Application Number: 10/723,046 (Peng et al.) Art Unit 2811 Amendment continued 7 of 18

REMARKS-General

FIG. 7 of the applicant's patent application

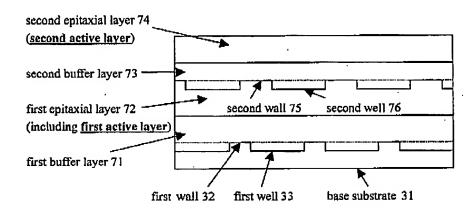
"Claim 9-11 recites the subject matters that a second texture formed on a first epitaxial layer that already comprises an active layer, implying that there are two active layers with the recited second texture there between. It apparently fails to reflect what is described in the specification, in which only one active layer for forming the recited devices is formed above the substrate."

To show clearly the distinctions between Wada and applicant, comparing with FIG. 7 of the applicant's patent application, shown as below:

Applicant requests reconsideration and withdrawal of the objection, because that applicant <u>dld</u> describe <u>two</u> active layers for the recited device. The following is the quotation from the specification of the original patent application for PIG. 7: "FIG. 7 shows a cross sectional view of epitaxial wafer. First texture comprising well 33 and wall 32 is etched on the top surface of substrate 31. First buffer layer 71 is grown on the first texture of substrate 31. First epitaxial layer 72 comprising first active layer is grown on the top surface of first buffer layer 71."

"Second texture comprising well 76 and wall 75 is patterned by etching on the top surface of first epitaxial layer 72. Second buffer layer 73 is grown on the second texture of first epitaxial layer 72. Second epitaxial layer 74 comprising second active layer is grown on the top surface of second buffer layer 73. Lights of different wavelength emitted from first epitaxial layer 72 and second epitaxial layer 74 are combined and emitted out of device."
